S E R V I C E N O T E

**4957A Protocol Analyzer**

**Serial Numbers:** 3125A00000 / 3125A00919

**Misloaded Diodes / A1CRV7, CRV13, CRV14**

Figure 1

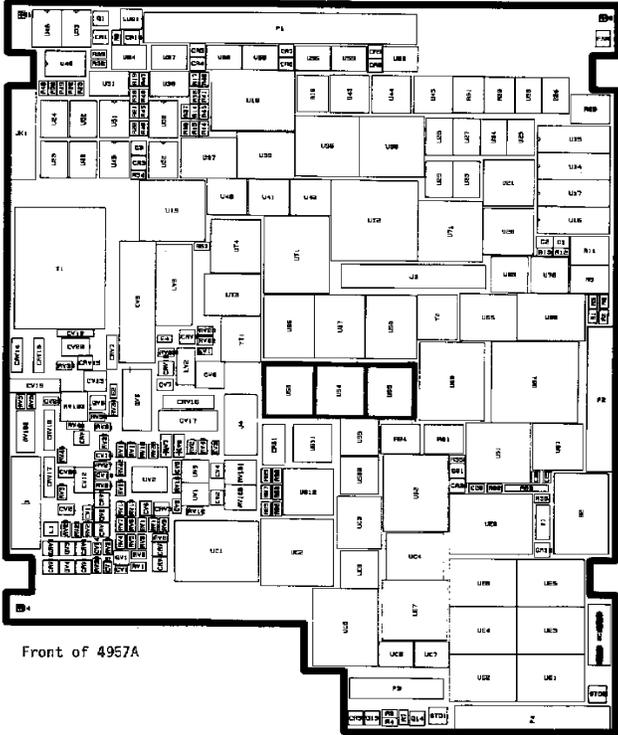
The analog circuitry of the 4957A has three diodes that are misloaded. One of the diodes, CRV14 may eventually cause a “No Display” situation and even cause physical damage to the PC board by overheating and burning the board.

- 2. Disconnect all cables from the top cover.
- 3. Using Figure 1, locate and remove CRV7, CRV13, and CRV14.
- 4. After removing the diodes place new diodes into the following locations

CRV7 & CRV13 ..... p/n 1901-1249 CRV14 ..... p/n 1901-1308
